Item ID: 646.3715 Accept ***N900040100*** Setup Start ***NS1***
Revision ID: Stop ***NS2***
Item Name: Strut Doubler
Start Date: 1/23/2017 Start Qty: 10.00 ***10*** Cust Item ID:
Required Date: 2/8/2017 Req'd Qty: 10.00 ***10*** Customer:
Reference:

APICAL INDUSTRIES, INC.	ENGINEERING CHANGE NOTICE NO. 03702				SHEET 1 OF 2	
	DWG NO. 646.3700	REV: A	PREPARED BY B. PETERS	DATE: 11/15/12	EFFECT ON DWG ☐ INC. ☒ UNINC.	
	DWG TITLE: SHEETMETAL					
APPROVED BY: ENGR. <i>[Signature]</i>		MFG. <i>[Signature]</i>		QC <i>[Signature]</i>	EFF: NEXT ORDER	
TRANSACTION CODES (TC): A-ADD C-CREATE R-REVISE D-DELETE		REASON: ADDED ALTERNATE MATERIAL AND REVISED REFERENCE DIMENSIONS				EOR: D-12-010

SHOP COPY
RETURN TO
ENGINEERING
UNCONTROLLED COPY
SUBJECT TO AMENDMENT
WITHOUT NOTICE
WORK ORDER
NO. 156833 mcs
170209

SHEET 1, ZONE A2 IS:

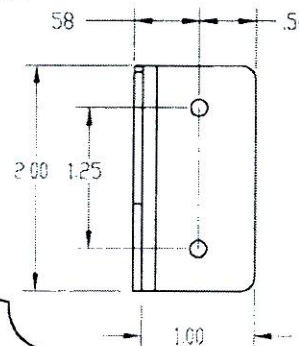
⚠ PRIMARY MATERIAL: ALUMINUM 6061-T6 PER AMS-QQ-A-250/11
ALTERNATE MATERIAL: SS 17-4 PH PER AMS 5604

**SHEET 7, ZONE C4 IS:****SHEET 7, ZONE D1 IS:****SHEET 7, ZONE B7 IS:**

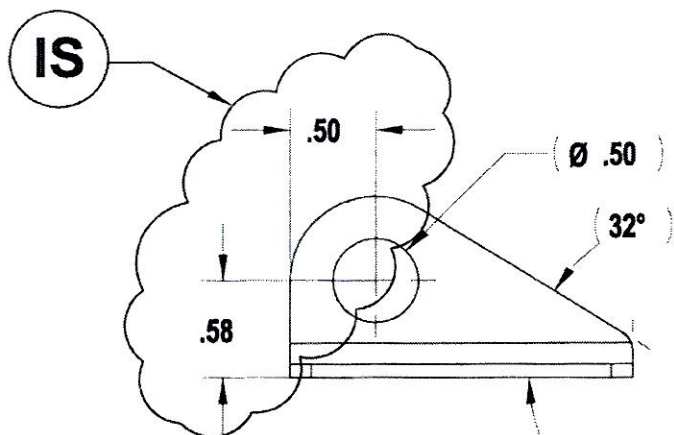
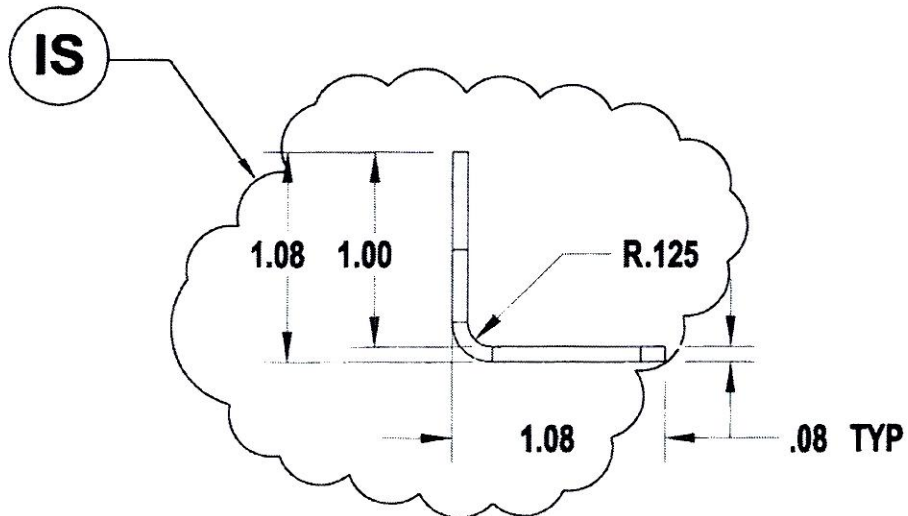
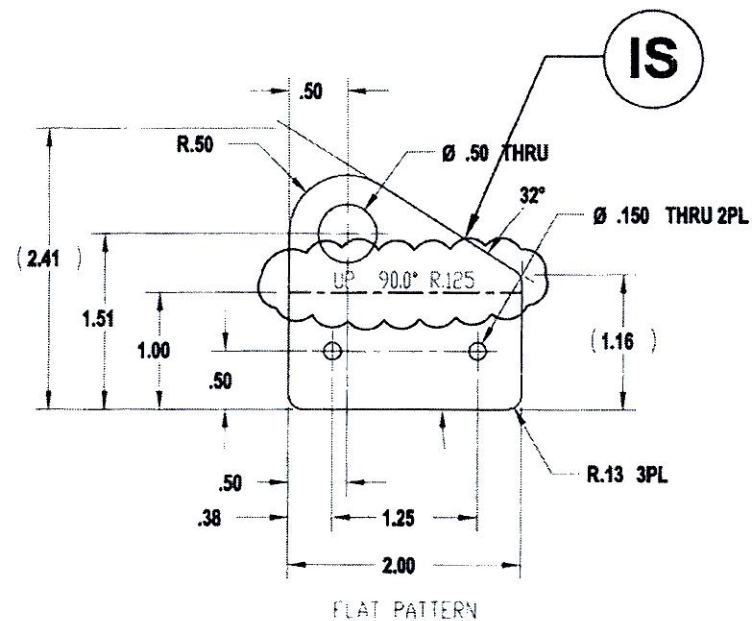
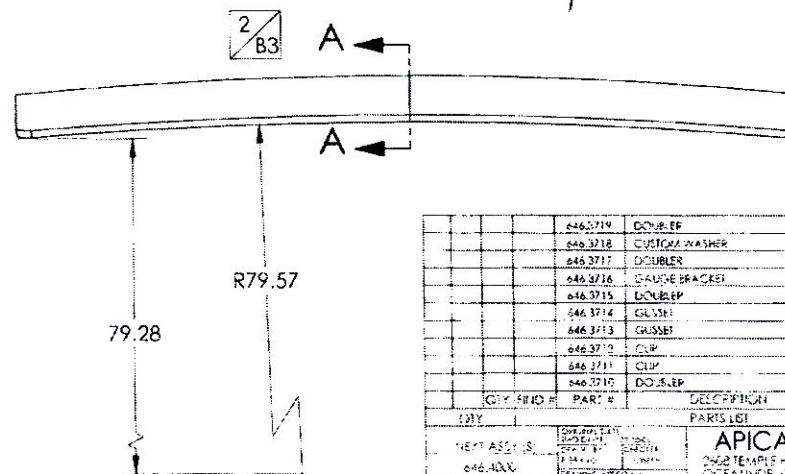
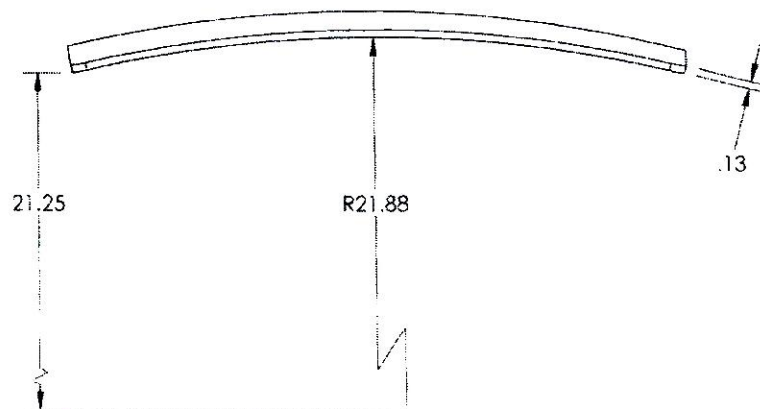
- 1 MATERIAL: ALUMINUM 6061-T6 PER AMS-QQ-A-250/11
- 2 FINISH: HARD ANODIZE IAW MIL-A-8625 TYPE III
CLASS 2, COLOR BLACK;
CARDINAL 4860-50 PRETREATMENT PRIMER
PRIME IAW MIL-P-23377J TYPE I CLASS N
- 3 MATERIAL: 1/4 PH AMS 5604 CONDITION H900
- 4 FINISH: PRIME IAW MIL-P-23377J TYPE I CLASS N
- 5 DEBURR AND BREAK ALL SHARP EDGES
- 6 IDENTIFY IAW MPP-120
